Preliminary Plan
Timber Trail Junction
 Montville Township

Meeting:	March 4, 2020	Sublots:	8
App. No.:	014-2019-CP	Zoning:	R-2 Single-Family Suburban Residential
Owner:	Tom Curran, Curran Homes	Utilities:	Central water and sewer
Engineer:	Rolling & Hocevar Inc.	School Dist.:	Medina City
Parcel Nos.:	030-11B-06-081	Reviewer:	Sonja Pagniano
Site Area:	8.1500-acres

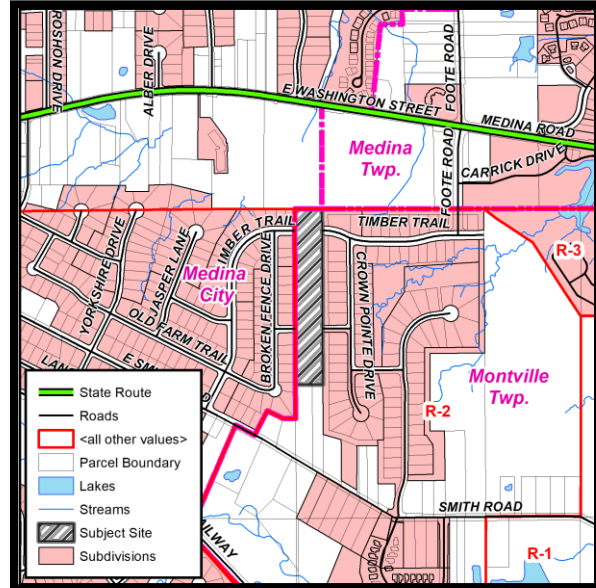
- Eight Sublots with Central water and sewer;
- Reinforced concrete pavement, public sidewalks along with extension of existing sanitary sewer and water main utilities;
- Two Stormwater Management Basins; Streams across the Northerly portion of the parcel;
- Three Variances approved by Montville Township Board of Zoning Appeals for Minimum Lot Area, Minimum Front yard Depth, and Minimum Rear Yard Depth;
- Extension of Timber Trail (80' ROW) & Mayapple Drive (60' ROW).
- Sublot 2 indicates wetland encroaching on a building envelope, wetland will need to be filled.

Site Conditions: The site is primarily cropland and open space. The site has gently rolling topography throughout and there are approximately 6 spots with wetlands of varying sizes. Staff is concerned with the amount of water channeling through Sublot 3; staff is wondering if studies have been done yet to determine the viability of that lot as well as the effects for Sublot 4.
